ADDENDUM NO. 5 TO PROJECT NO. 43153

**CONSTRUCTION WORK, MECHANICAL WORK,
PLUMBING WORK, ELECTRICAL WORK
PROVIDE VISITOR CENTER BUILDING AND SITE IMPROVEMENTS
FIVE RIVERS ENVIRONMENTAL EDUCATION CENTER
56 GAME FARM ROAD
DELMAR, NY 12054**

July 9, 2015

ROOF PLAN

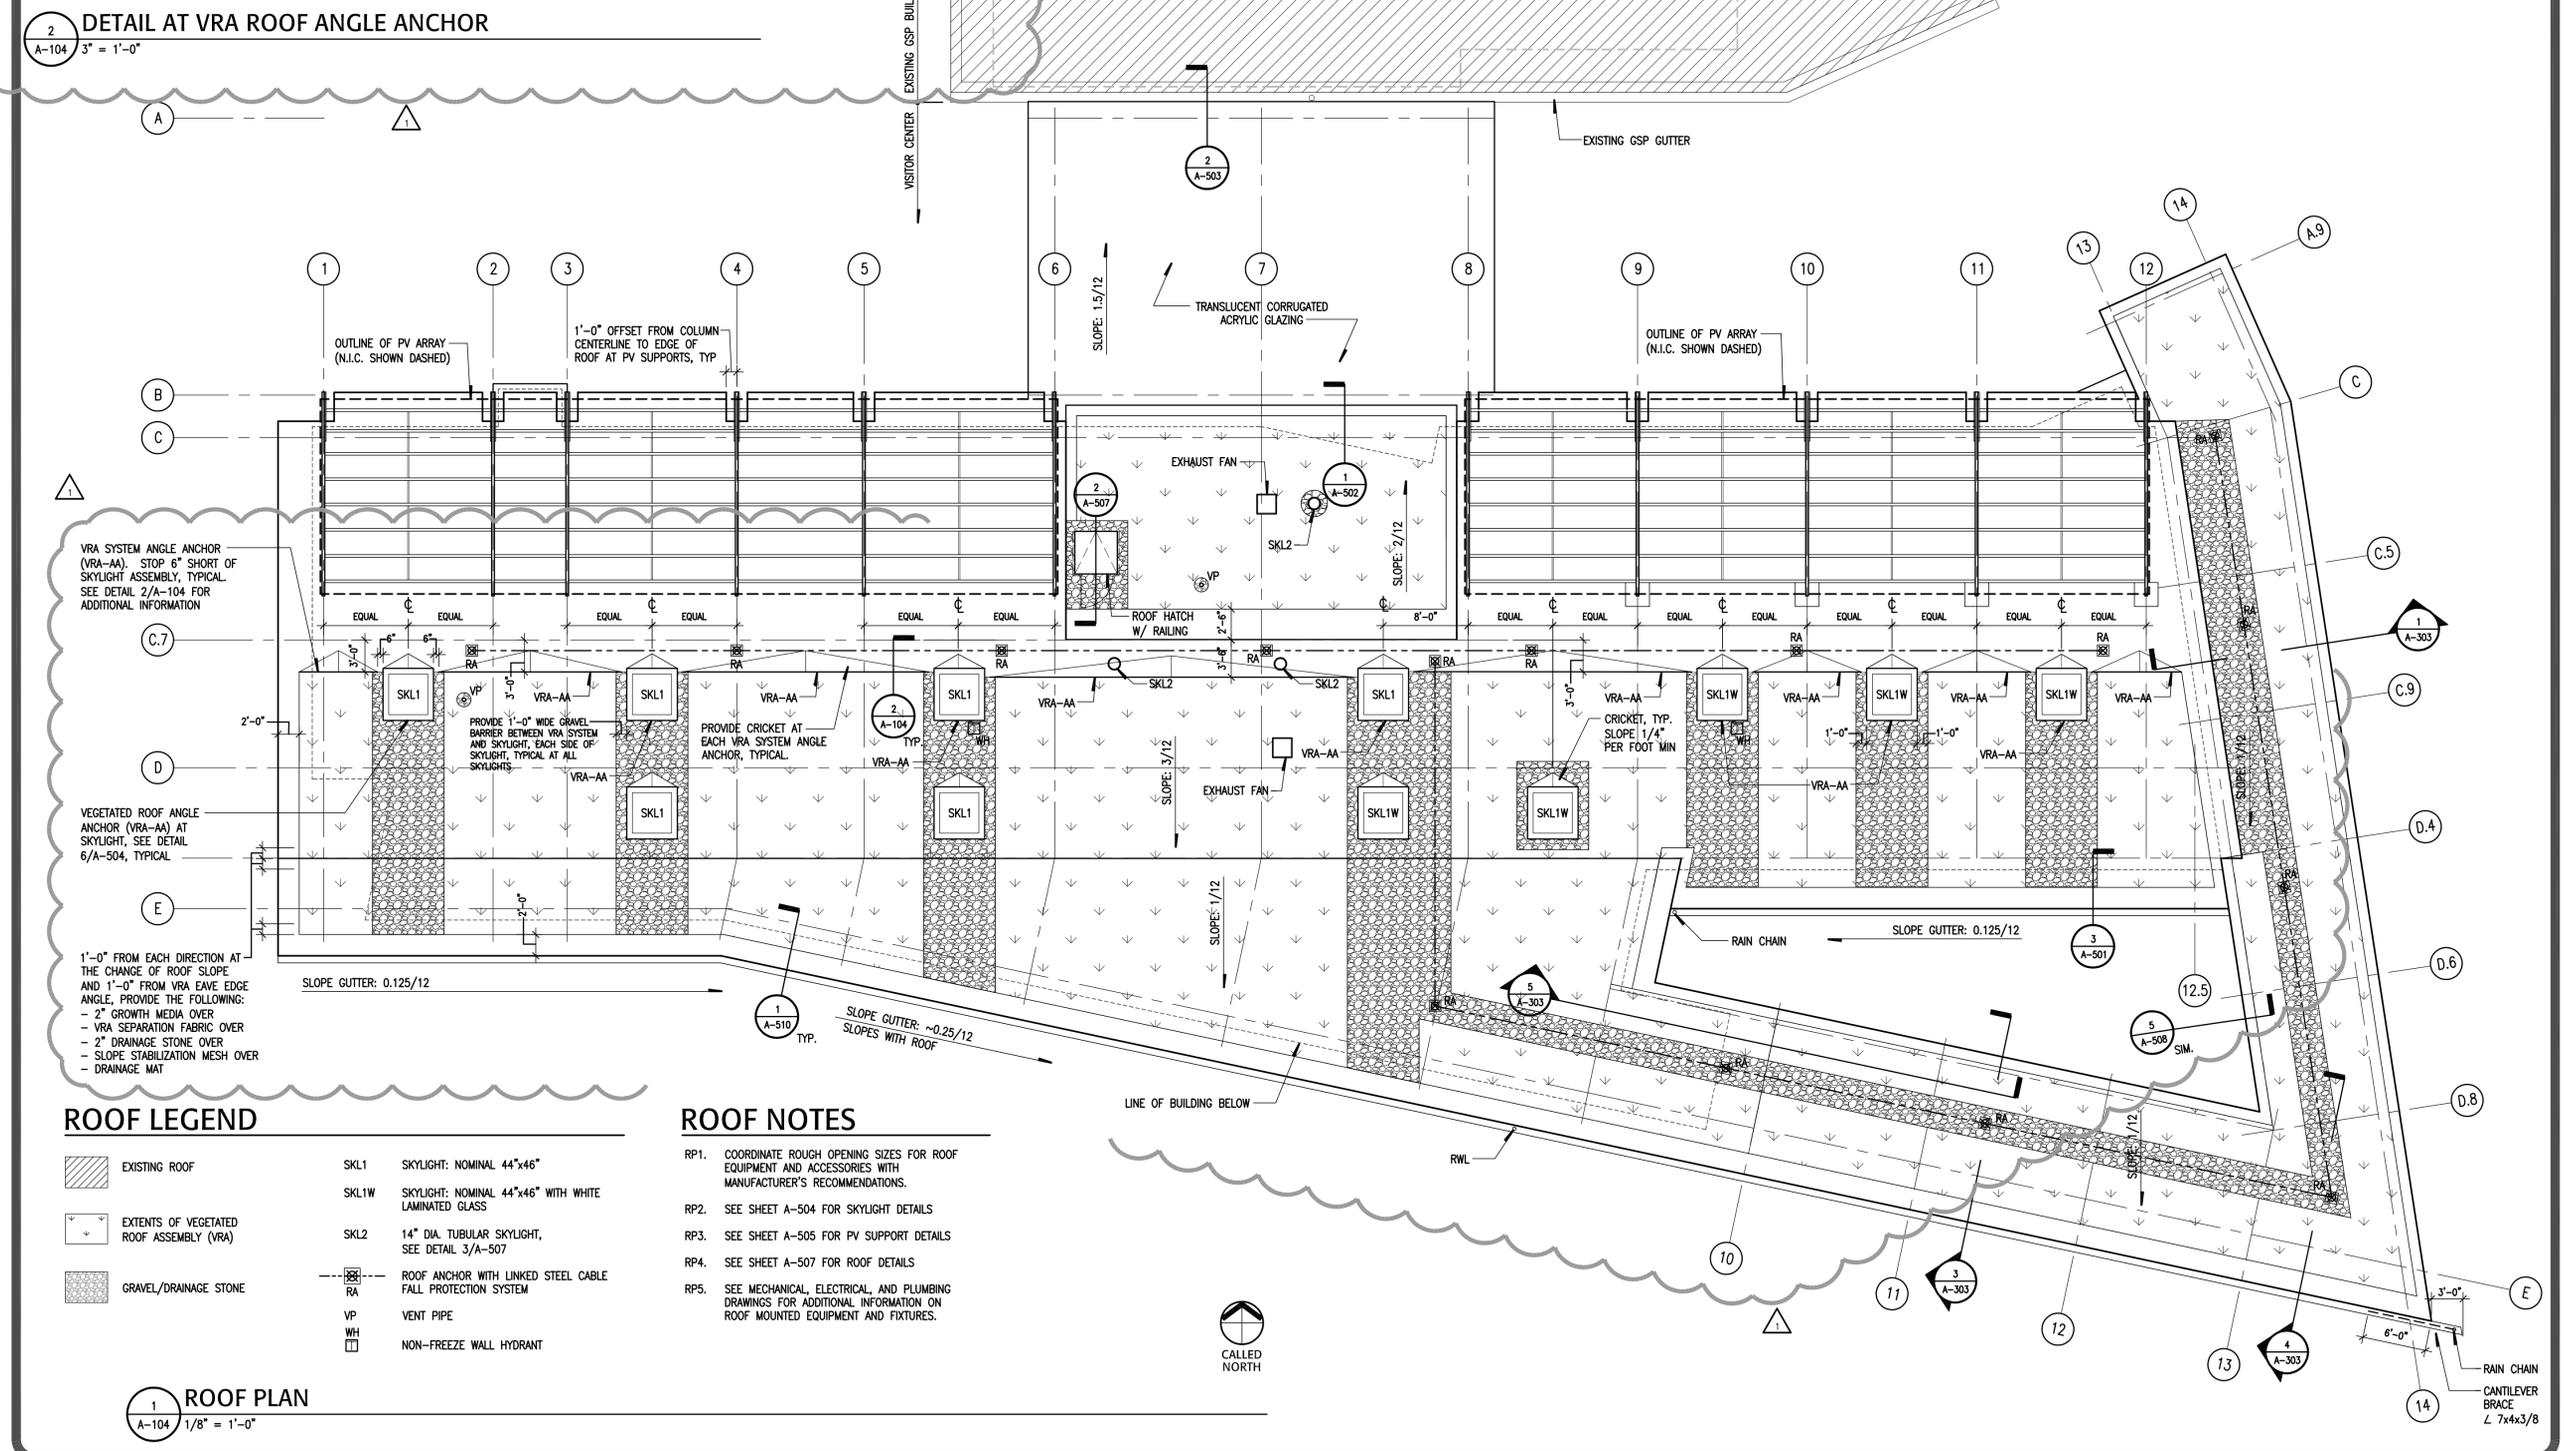
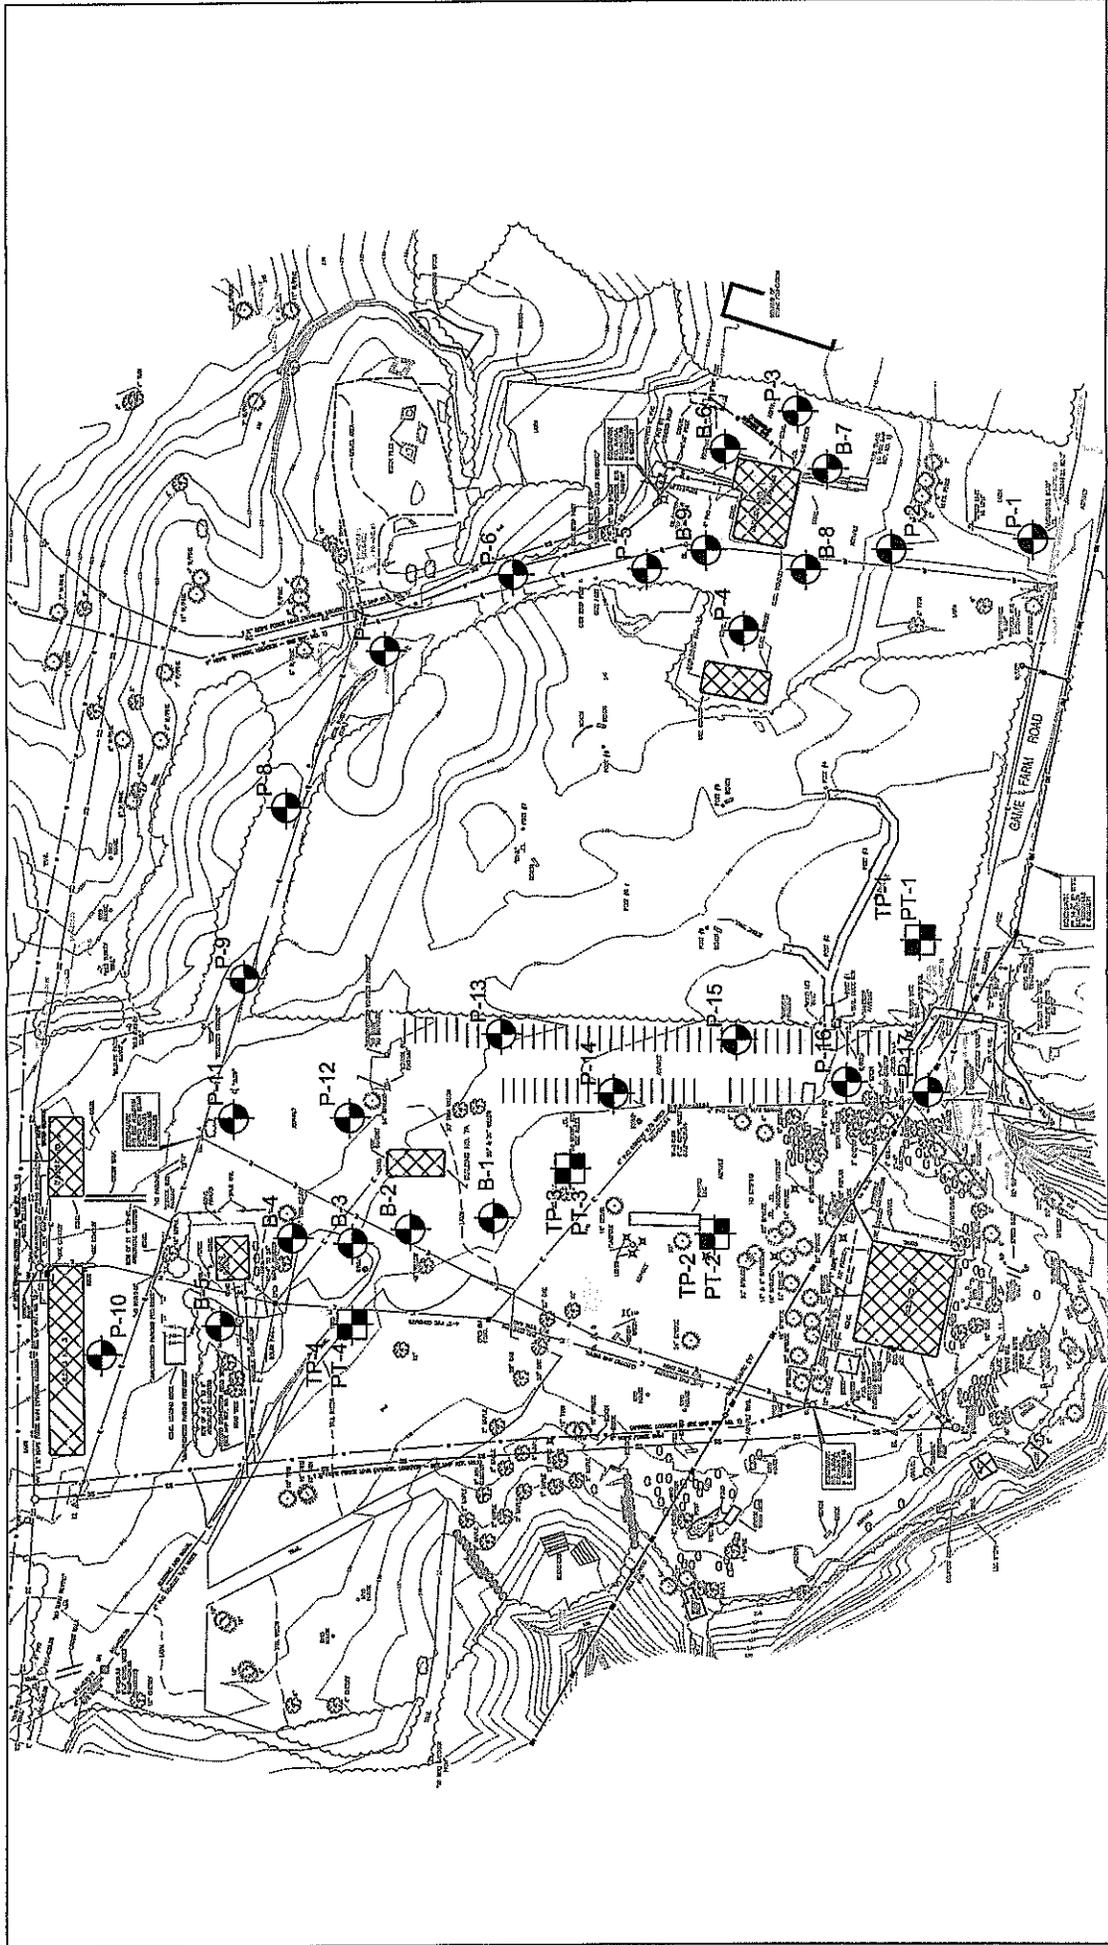
9. Sheet A-104 Roof Plan

- a. Replace sheet A-104

- B. Root Barrier: See Section "075323 "Ethylene-propylene-diene-monomer (EPDM) Roofing"
- C. Anti-Slip Devices: Manufacturer's standard anti-slip devices.
- D. Vegetated Roof Assembly Anchor Angle: See sheet A-104 for additional information on stainless steel angle and tube required to brace slope-stabilization mesh.
- E. Recycled Content: Provide moisture-retention mat, molded-sheet drainage panels, protection fabric, and separation geotextile material with recycled content so postconsumer recycled content plus one-half of preconsumer recycled content not less than 100 percent by weight.

DRAWING NUMBER:
FS-301

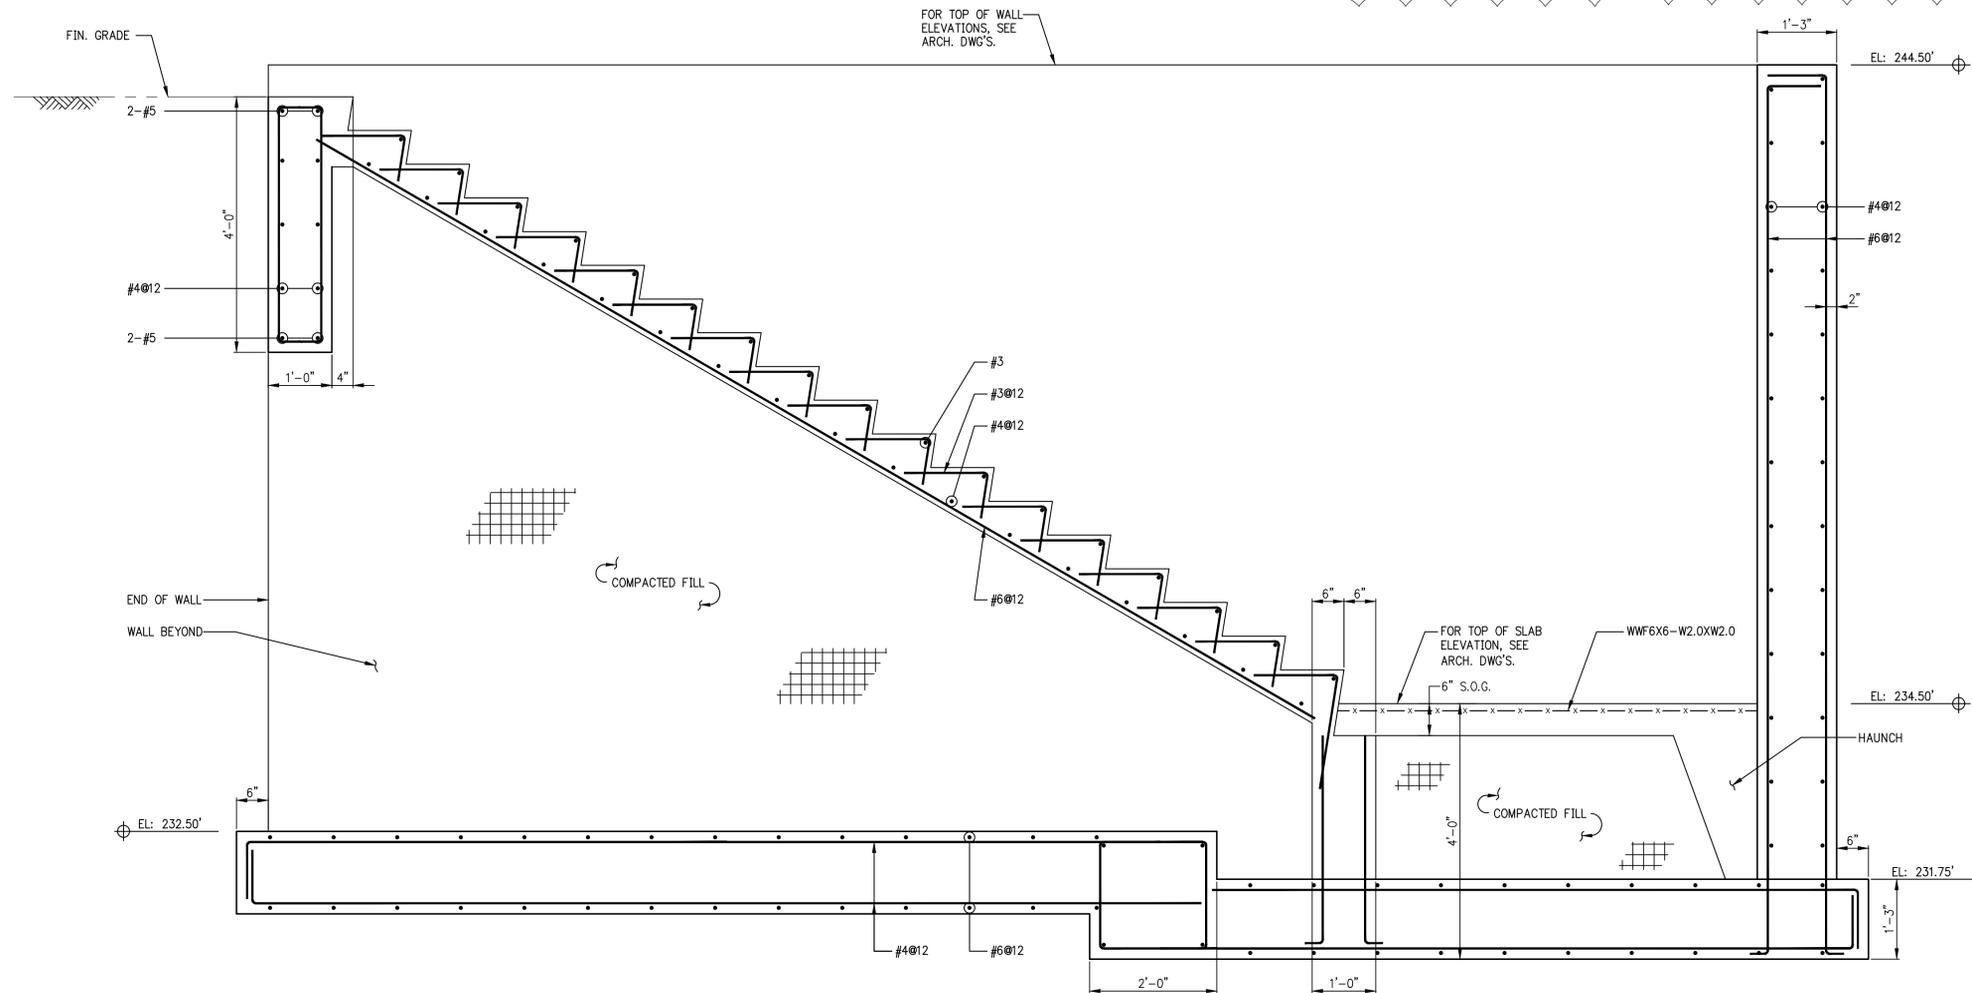
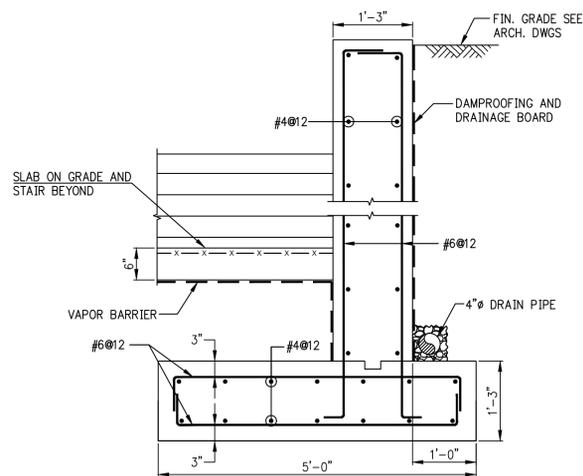
1. Sheet C-110 Layout Plan Overall
 - a. Paths I1, I2, H2, H3, and F shall be constructed using stone dust.
2. Sheet FS-100 Foundation Plan
 - a. Replace sheet FS-100
3. Sheet FS-301 Foundation Sections II
 - a. Add sheet FS-301
4. Sheet S-600 Typ. Superstructure Details & Notes
 - a. Add columns C.7/6, C.7/7, C.7/8 to column schedule, columns shall be 12” diameter.
5. Sheet S-601 Typ. Superstructure Details & Notes
 - a. Detail 1: Add note for angles shown but not labeled at top of shear wall to read: “L 4x4x1/4” AT EACH STUD, BOTH SIDES OF WALL.” Delete reference to SP6 at each stud.
6. Sheet A-602: Typ. Superstructure Details & Notes II
 - a. Add detail 16/S-602
7. Sheet A-101 General Notes and Basement Plan
 - a. Replace sheet A-101
